EXPLANATION OF SIGNIFICANT DIFFERENCES

**NYANZA CHEMICAL WASTE DUMP SUPERFUND SITE
(Operable Unit 2)**

ASHLAND, MASSACHUSETTS

September 2006

Figure 2

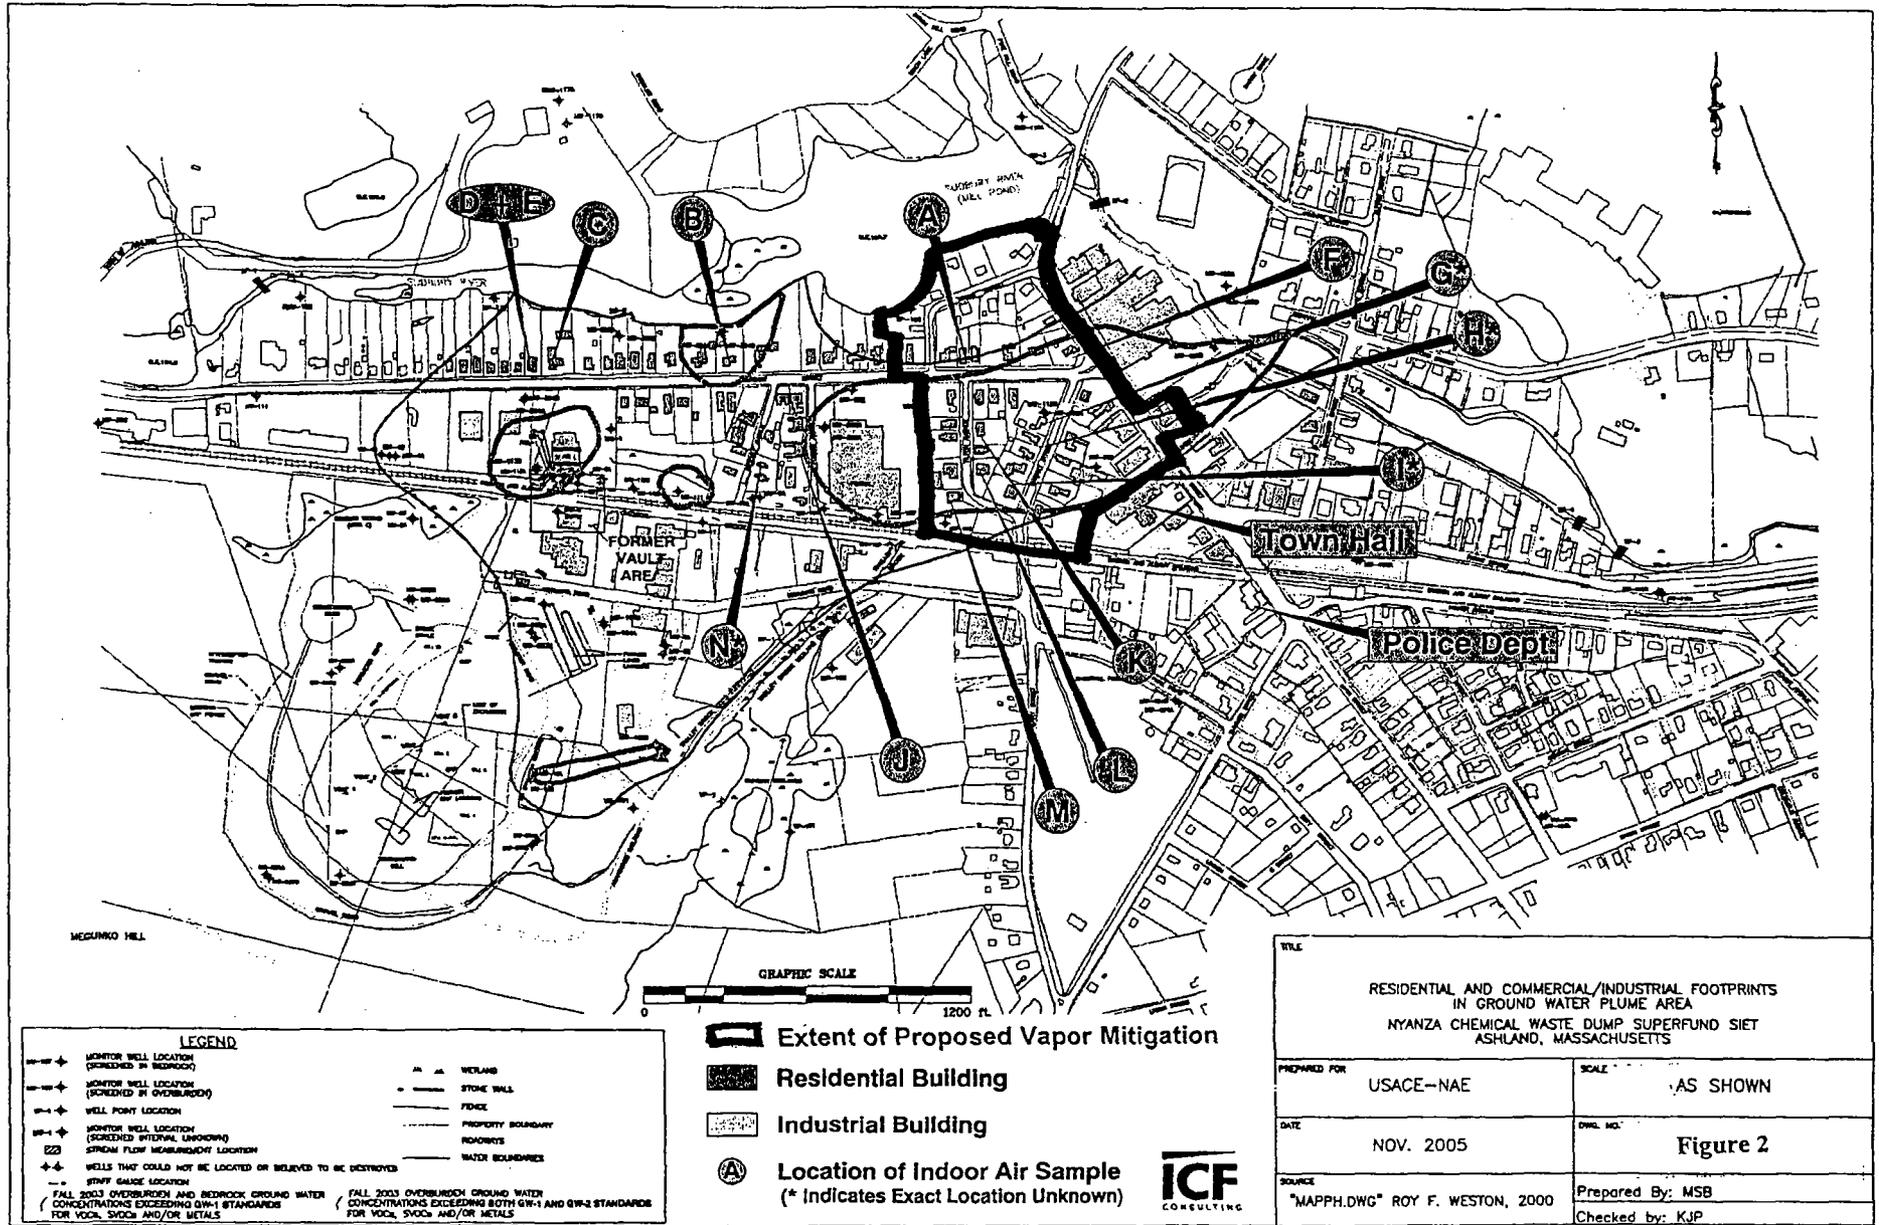
Complete results from all three indoor air sampling events are attached in Table 1. Figure 2 shows the corresponding sampling locations.

This ESD also requires installation of vapor mitigation systems in structures (primarily homes) located above the most contaminated area of the plume. This area of approximately 40 to 50 structures (mostly homes) is generally bracketed by Tilton Ave. and Water St. to the west, the Sudbury River to the north and to the east, and the rail road tracks to the south and shall be identified as Phase I (see Figure 2). This area was selected because:

Figure 3

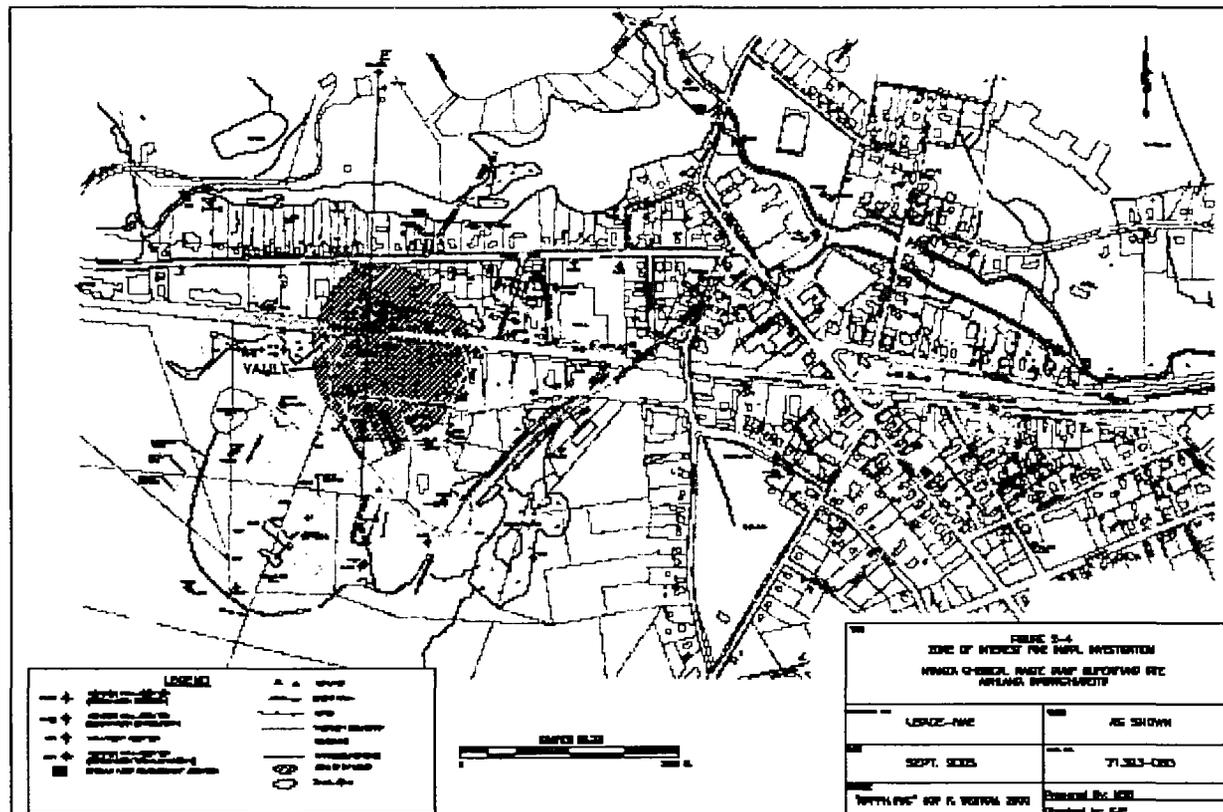
These results indicate that a pool of highly contaminated DNAPL located about 40 to 50 feet deep at the bottom of the aquifer and within the fractures of the top 20 feet of

bedrock, extending over about a 1 acre area, continues to act as a source for groundwater contamination. Figure 3 shows the general DNAPL area. The conclusion was reached that the DNAPL must be removed or otherwise addressed for any successful remediation of groundwater to be possible.

Figure 5

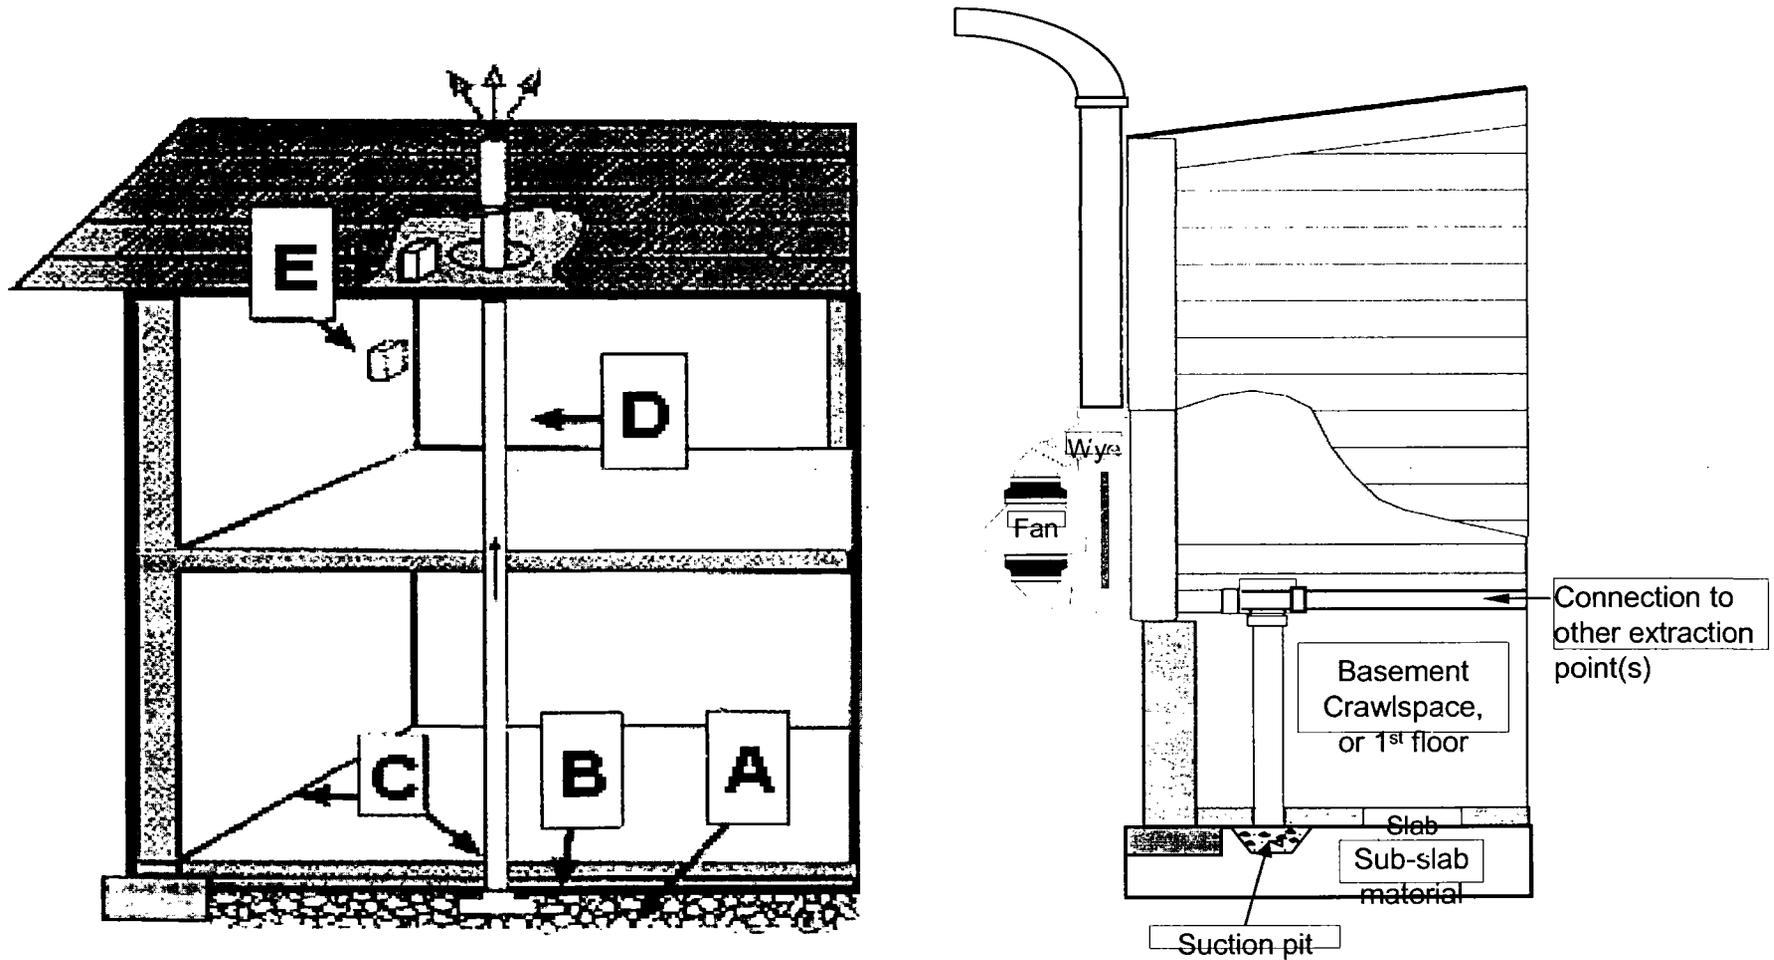
The active vapor mitigation systems consist of small diameter PVC pipes, which are attached to a continuously operated fan. The system works by installing one or more pipes through the basement floor and into the sub-slab area. The piping is then routed outside the home and above the roof line where the vapors are allowed to discharge into the atmosphere. Once discharged, the vapors are diluted and no longer pose a potential threat. A single small-diameter approximately 90 watt fan is placed along the piping route (outside) to maintain a positive pressure and continually draw the vapors from the sub-slab to the atmosphere. A diagram of a typical active vapor mitigation system is shown in Figure 5.
